The Tauranga Airport understands the Port is seeking resource consent for its proposed Stella Passage development through the Fast-Track consenting process. Associated with the Stella Passage Development is the inclusion of additional ship to shore container handling cranes as shown on drawing 270-118 Rev A and 324-239 Rev 0.

**CRANE HEIGHT RESTRICTIONS
SULPHUR POINT**

CRANE ELEVATION
PROPOSED SOUTHERN WHARF EXTENSION
SULPHUR POINT

DETERMINATION OF HAZARD IN NAVIGABLE AIRSPACE

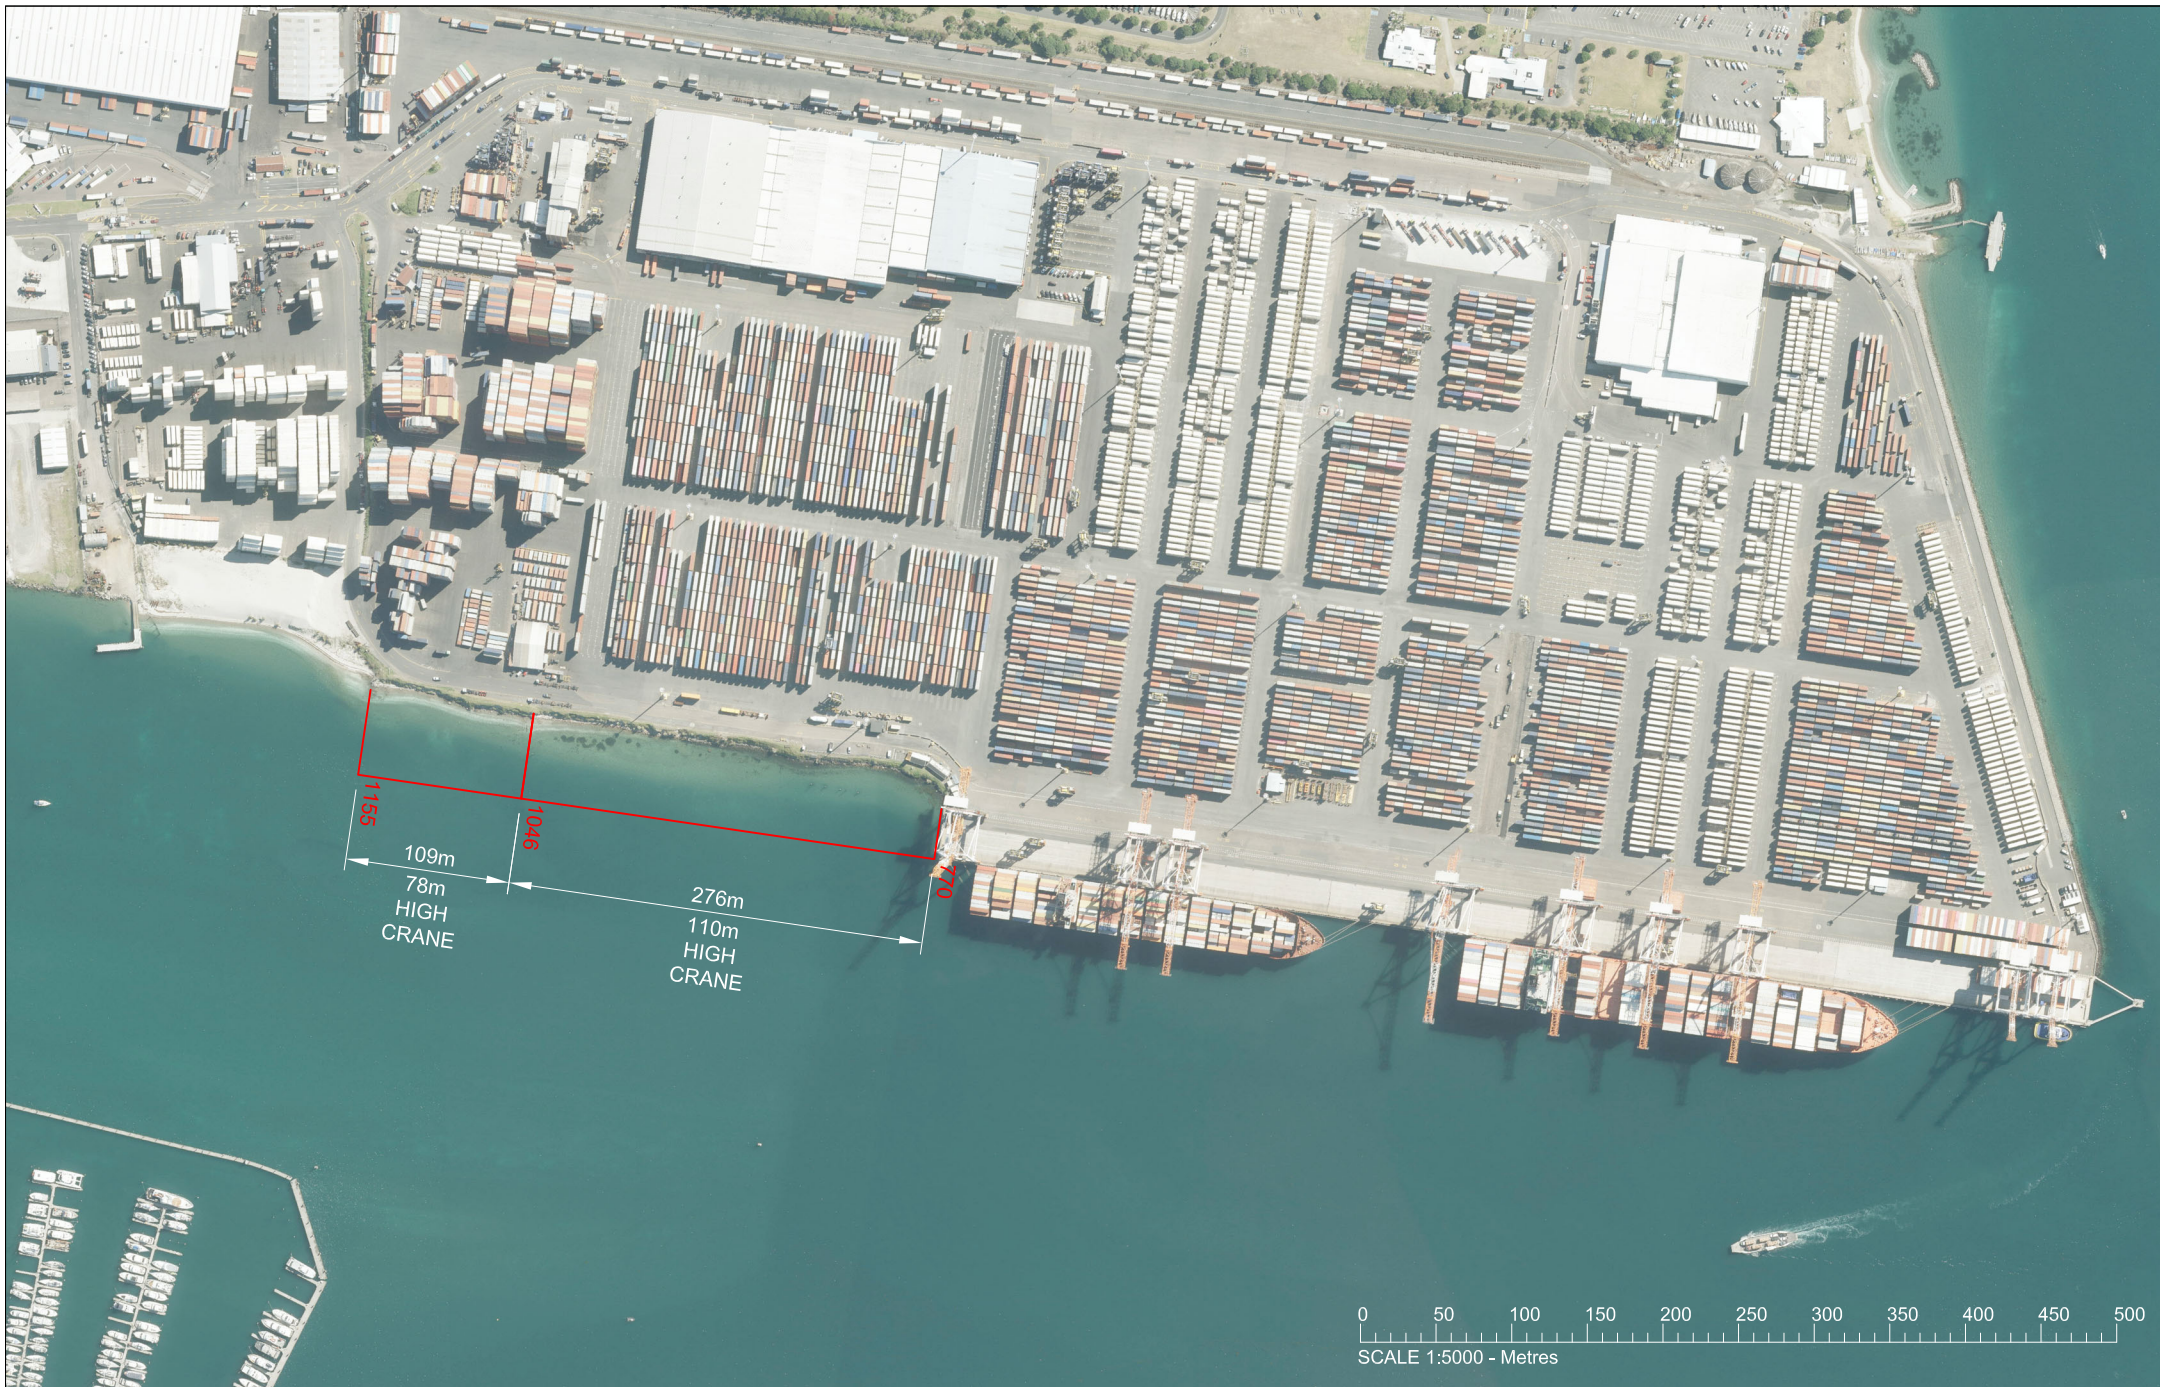
The Tauranga Airport acknowledges the proposed cranes will exceed the permitted height limits of both the Bay of Plenty Regional Coastal Environment Plan (Rule PZ 4) and the Tauranga City Plan (rule 18A.12.3). Under both these rules resource consent is required, and the assessment matters relate directly to the safe operation of the Tauranga Airport.

As per my email of 10 October 2024 the Tauranga Airport is in support of the proposed extension with the provision that Port of Tauranga complies with the below condition 1 of the attached CAA determination, Tauranga Airport will look after the remaining conditions.

1. The cranes operating within the proposed area must be continuously lit at the highest point of the crane and at the end of the boom with an appropriate obstacle light in accordance with (IAW) Civil Aviation Rule Part 77, Appendix B; and

Figure 04-1 Tauranga City District Plan OLS

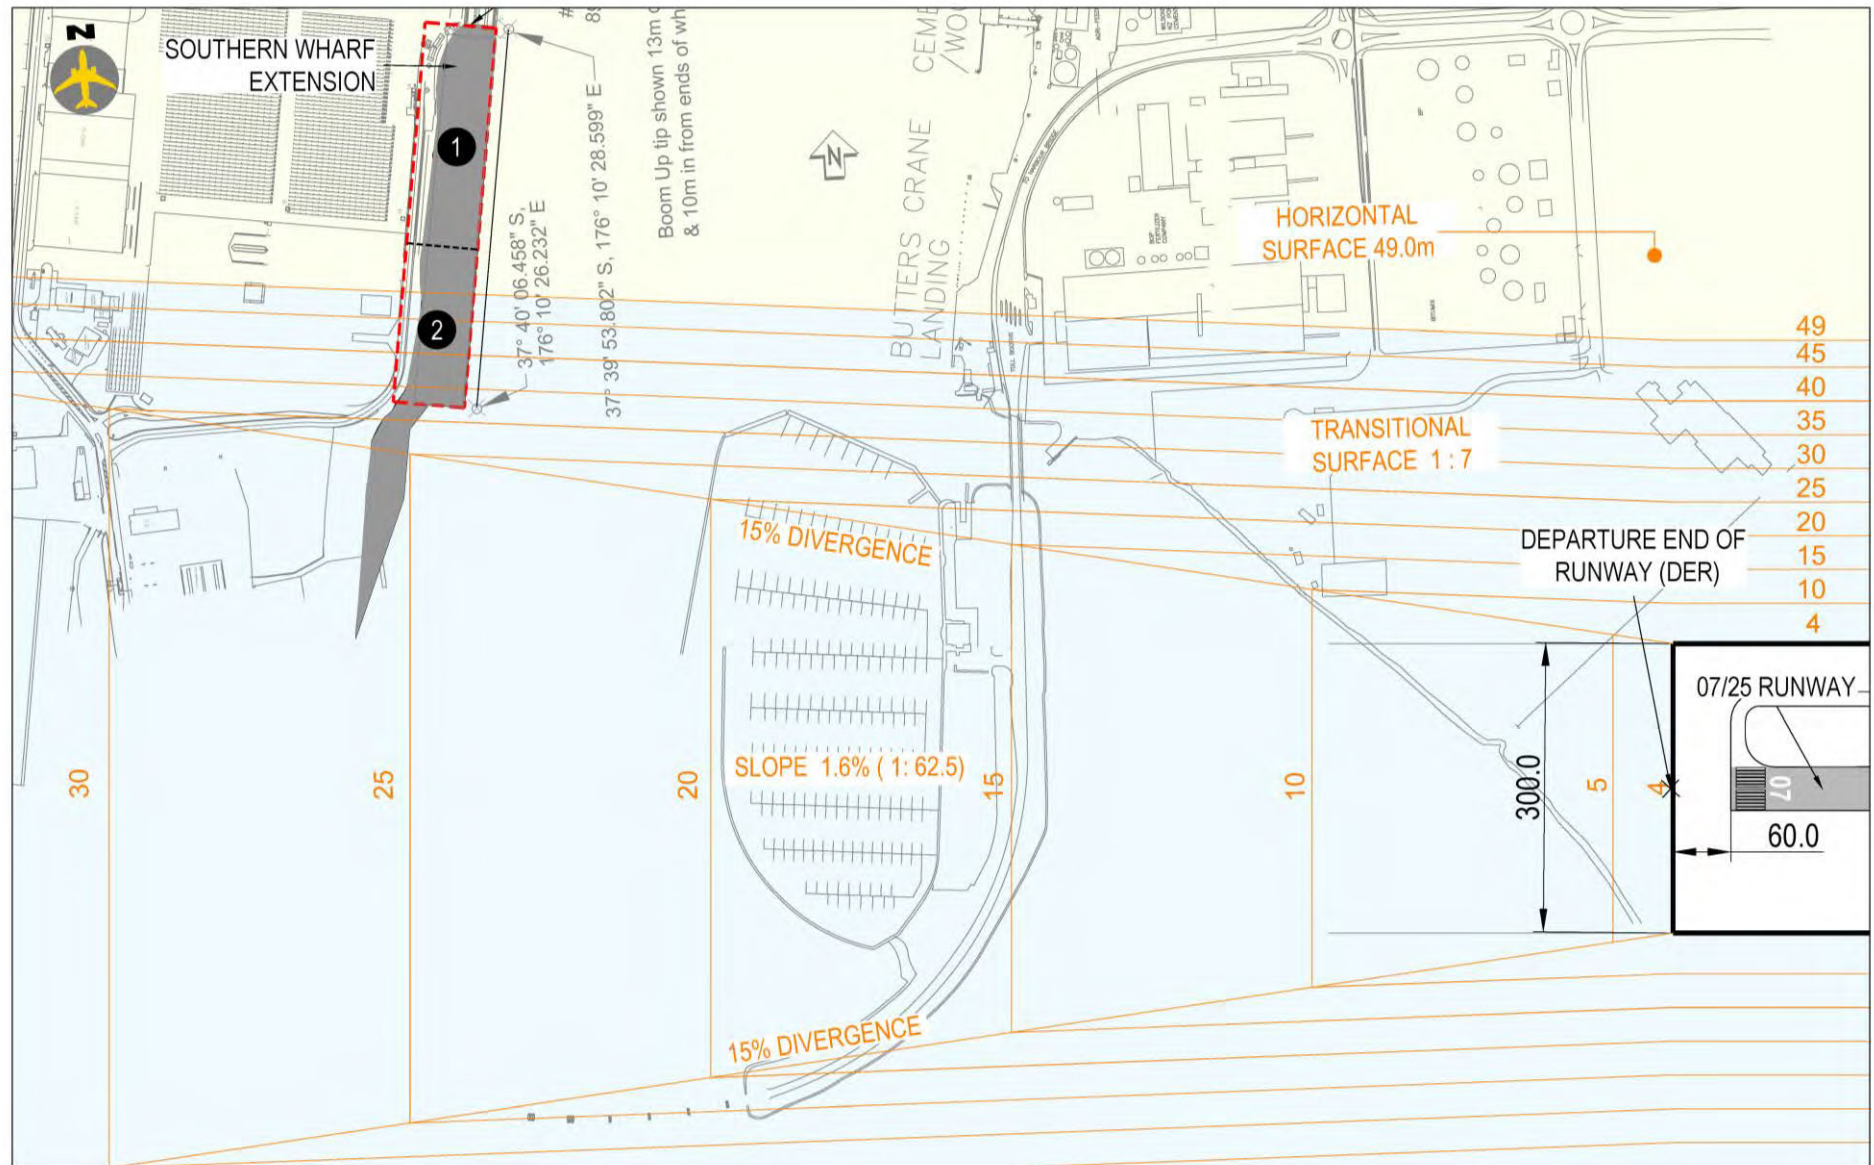
For the 220m wharf extension, denoted as Area 1 in Figure 04-1, there would not be an infringement of the Transitional Side Surface.

For the possible longer term additional extension to the full 385m extent, denoted as Area 2 in Figure 04-1, there could be potential infringements of the Transitional Side Surface in the southernmost 120m of the wharf extension, occurring as low as the 32m contour of the Surface, depending on what obstacles might be installed or present there, which could include:

Figure 04-2 OLS Based on Declared 150m Runway Strip

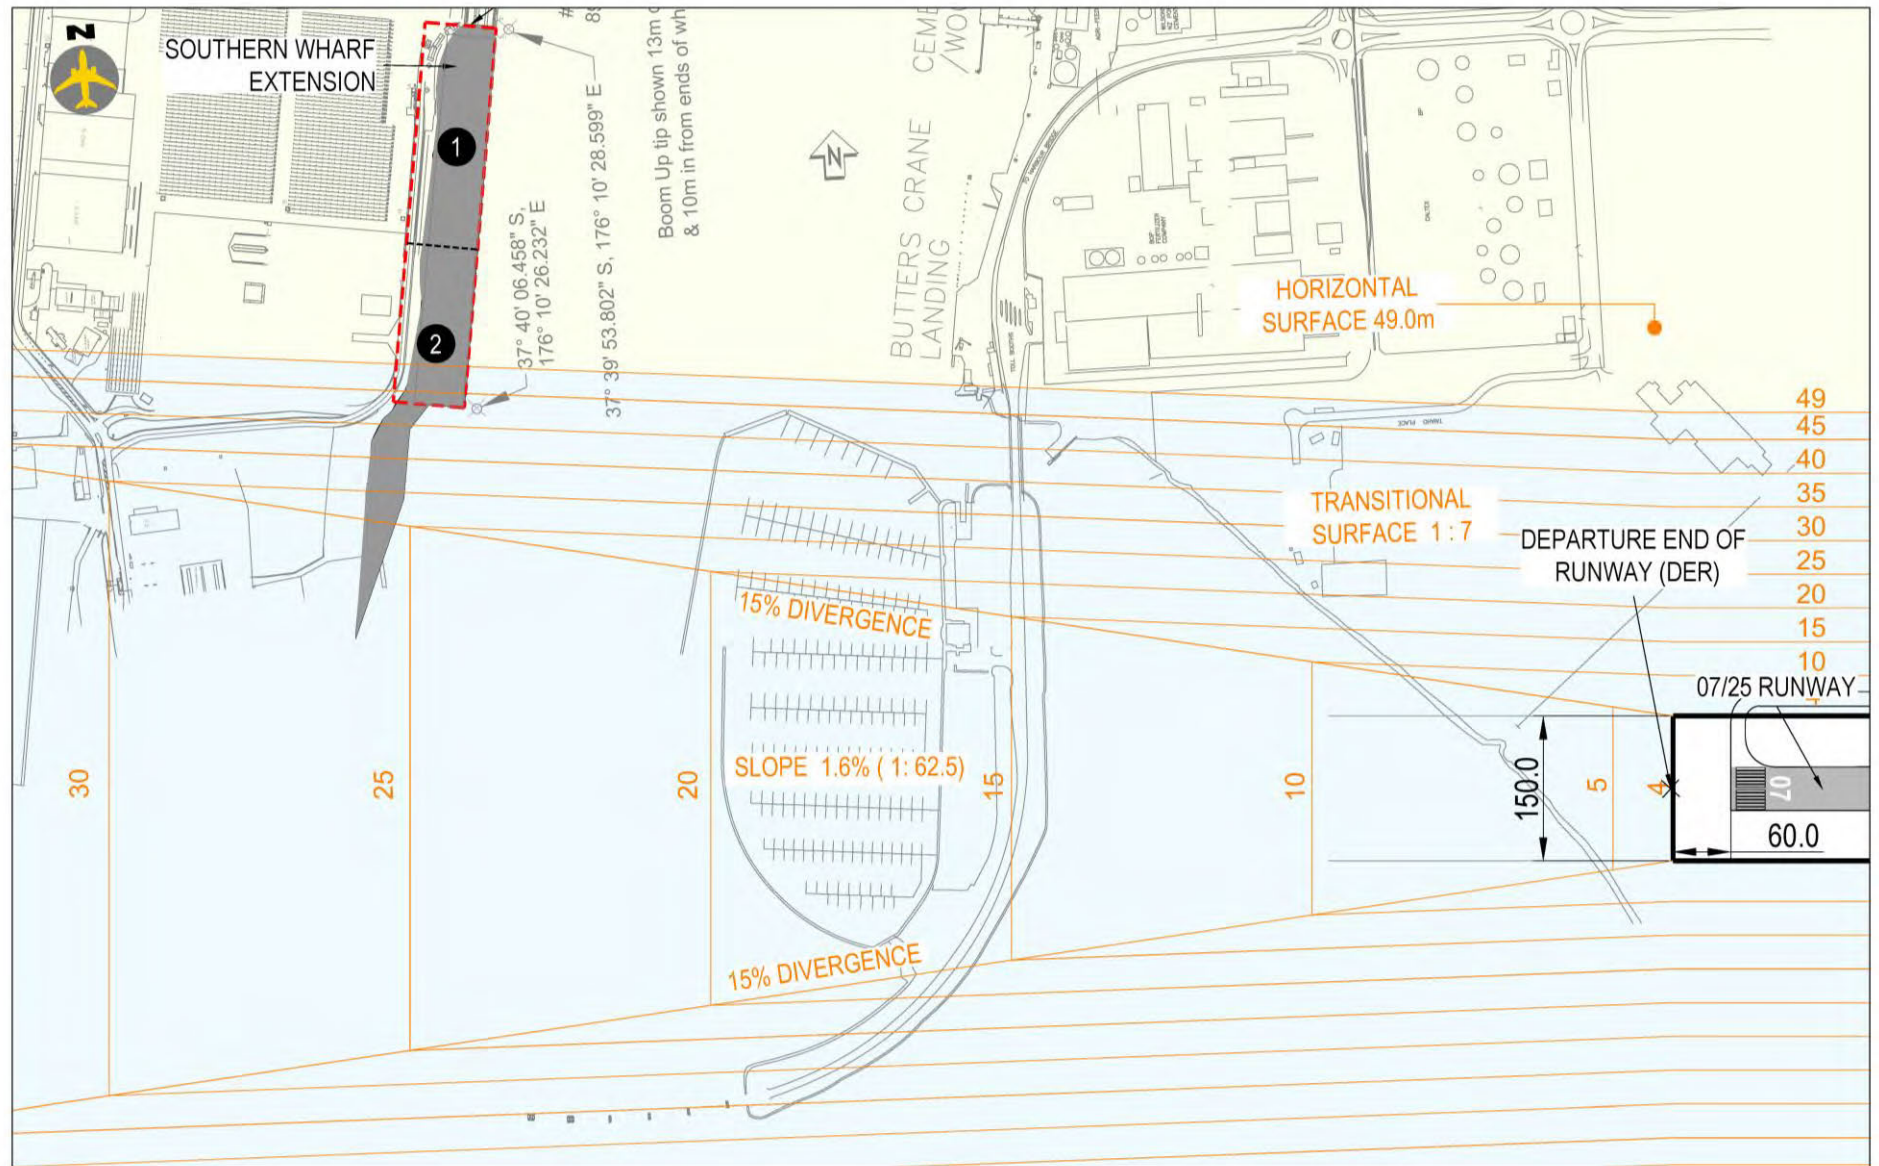
If the OLS were based on declared 150m runway strip width the extent of the Side Transition surface breach would be reduced. The potential infringements of the Transitional Side Surface would then be in the southernmost 45m of the longer term additional extension to the full 385m extent wharf extension, occurring as low as the 43m contour of the Surface. The reduced Transitional Side Surface breach is shown in Figure 04-2.

Figure 05-1 Departure Splay with 6.5% Climb Gradient

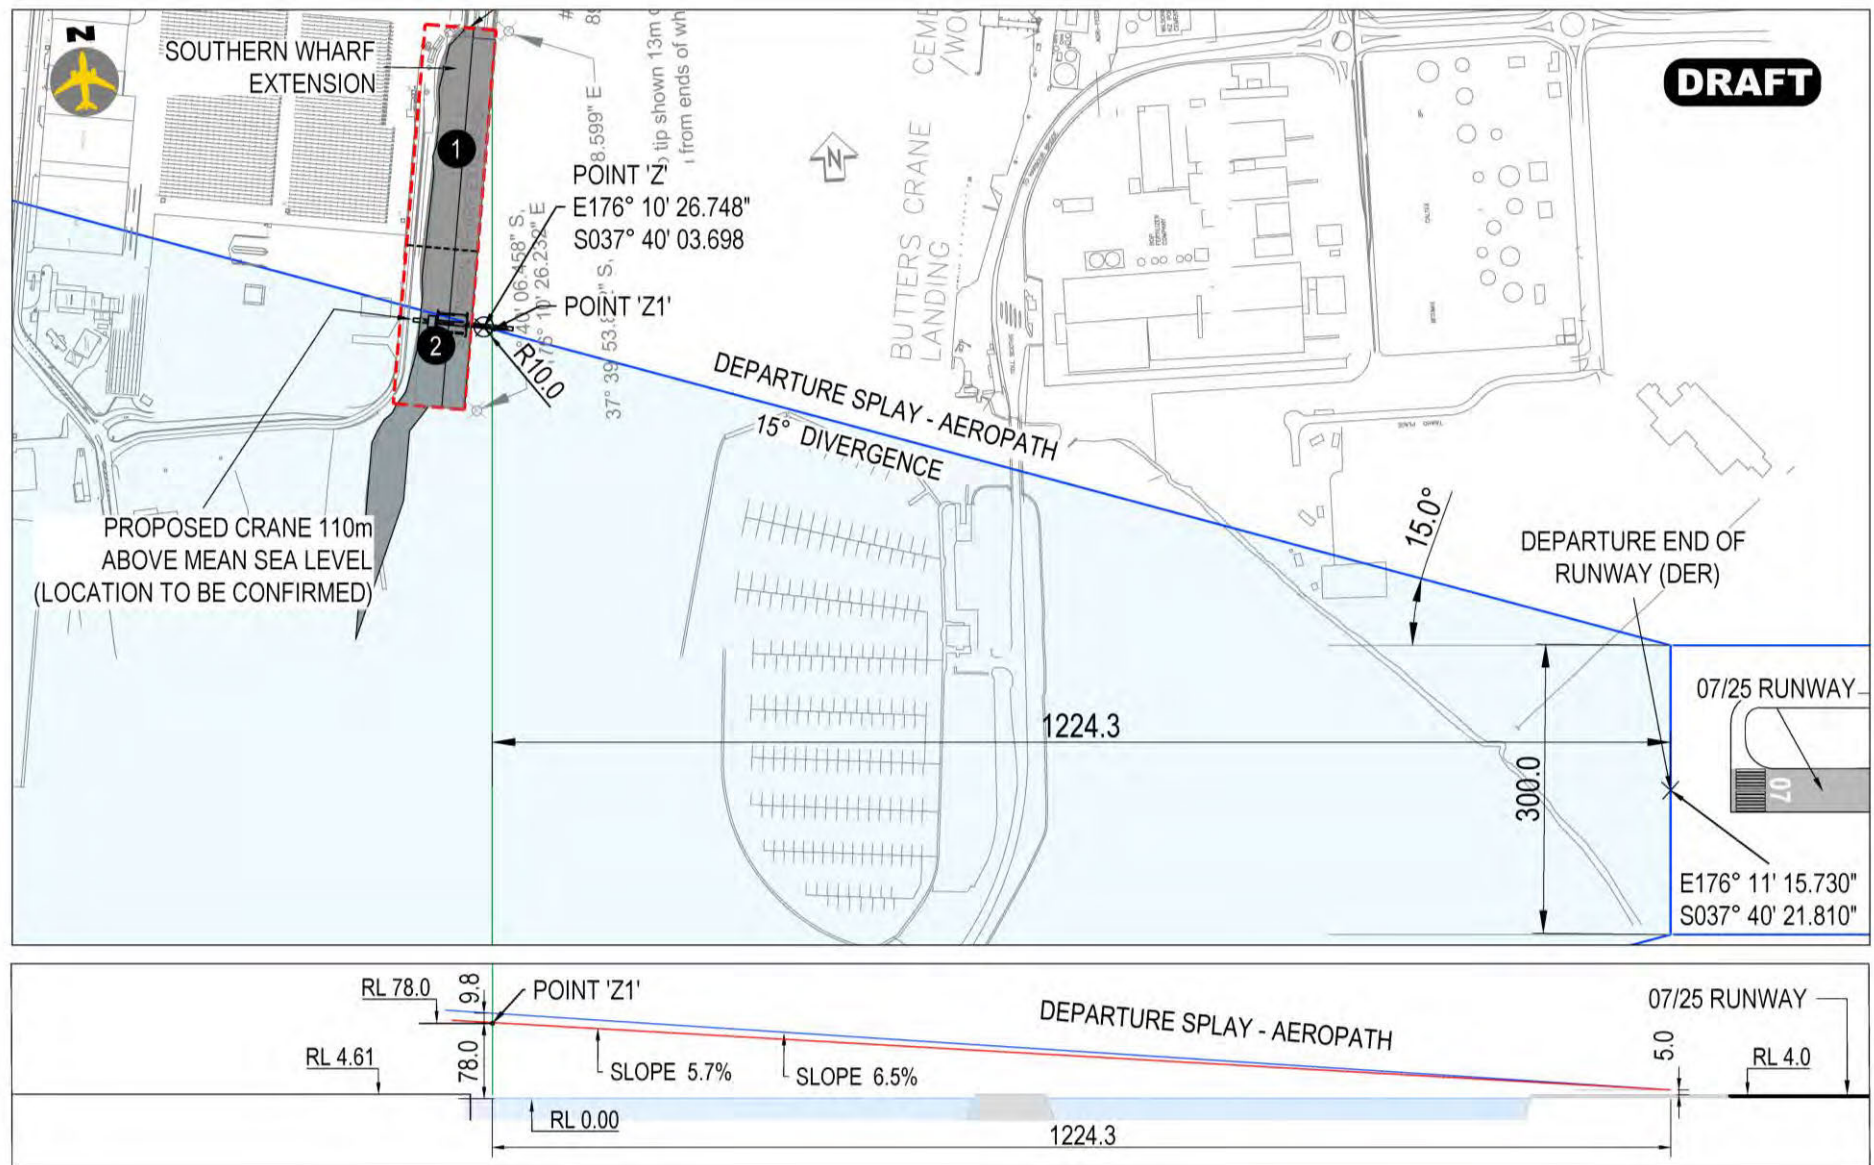
The critical aspect is the requirement that any obstacle must not infringe the Splay surface, potentially restricting installations in the southern-most half of the longer term additional extension to the full 385m extent, denoted as Area 2 in Figure 05-1 an extent of approximately 90m at the southern end.

obstacles installed on the proposed Wharf extension of 78m (depending on obstacle location). This is illustrated in Figure 05-1.

2. The proposed cranes must be marked IAW Civil Aviation Rule Part 77, Appendix B; and
3. All Cranes located within the SID Fan must not exceed a maximum height of 78m AMSL in order to preserve a maximum climb gradient of 6.5% for all Runway 25 SIDs; and

It is understood that Aeropath and Air New Zealand will be prepared to work together to achieve the modified procedures to achieve this mitigation.
